UNITED STATES PATENT AND TRADEMARK OFFICE

10/799,396

Office Action Summary	Application No. 10/799,396	Applicant(s) RHEE ET AL.	
	Examiner LUCY P. CHIEN	Art Unit 2871

DETAILED ACTION

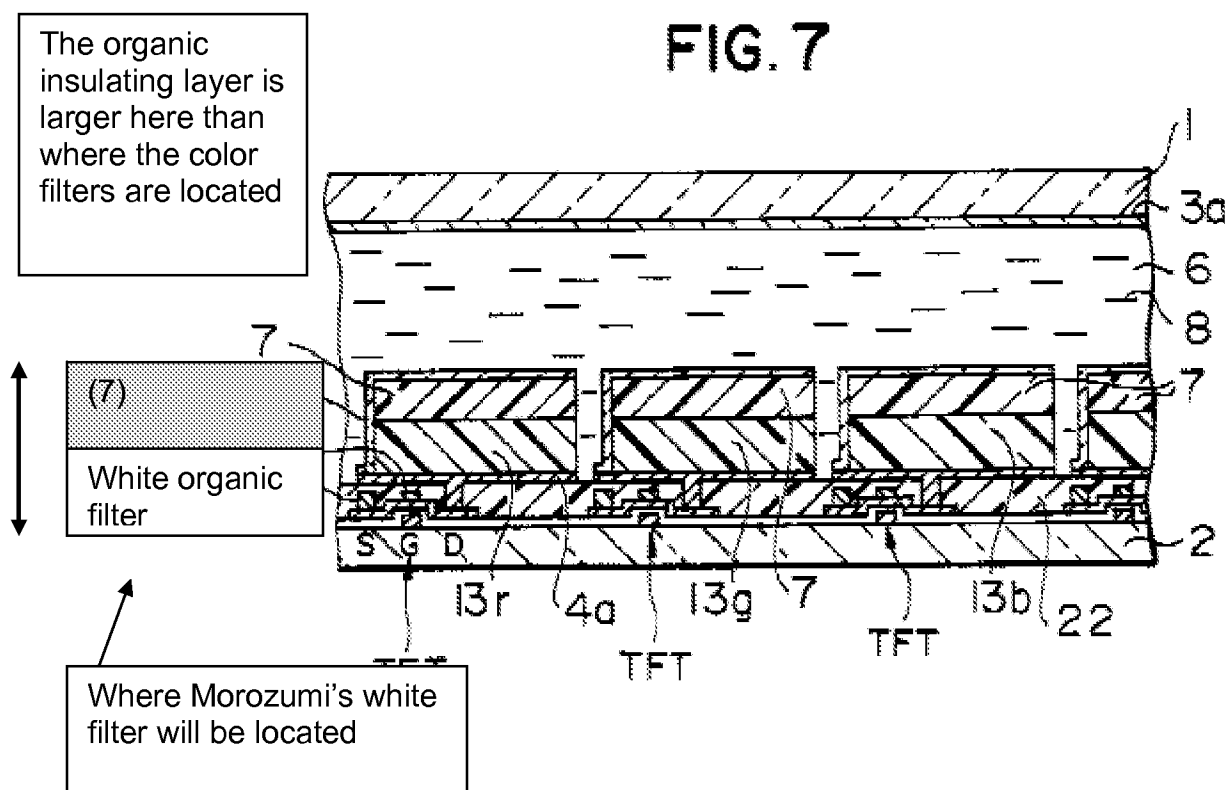
Kataoka et al discloses (Figure 7) an insulating substrate (2), a plurality of thin film transistors (TFT) formed on the substrate (2). A plurality of three primary color filters (13r,13g,13b) formed on the thin film transistor (TFT); a plurality of pixel electrodes (4b on top of 13r, 4b on top of 13g, 4b on top of 13b) formed on each of the color filters (13r,13g,13b) and connected to the thin film transistors (TFT) to complete a liquid crystal display with color filters; and a single layer structured organic insulating layer (7 is made of a polymer which is organic) including a plurality of first portions (7) disposed between the color filters (13r,13g,13b) and the pixel electrode (4b). A third organic insulating portion (22) that connects the first and second portion.

Kataoka et al does not disclose the second portion of the organic insulating layer disposed on the transparent areas.

Morozumi discloses (Fig. 16) (column 10, row 48-60) the second portion of the organic insulating layer disposed on the transparent areas (white color filter).

When adding Morozumi's white filter (which is an organic insulating layer also) to Kataoka et al's display (Fig. 7) it will be manufactured the same and thus the organic insulating layer (7) including a plurality of first portions disposed between the color filter (13r,13g,13b) and the first pixel electrode (4b) and a plurality of second portions (which is Morozumi's white organic insulating filter and the insulating layer (7) of Kataoka et al under the second pixel electrodes has a thickness larger than the first portions (7 shown above 13r,13g,13b)

It would have been obvious to one of ordinary skill in the art, at the time of the invention to modify Kataoka et al's color display device to include Morozumi's white filter and second pixel electrode to improve the overall brightness of the display (Column 10, Rows 54-60).
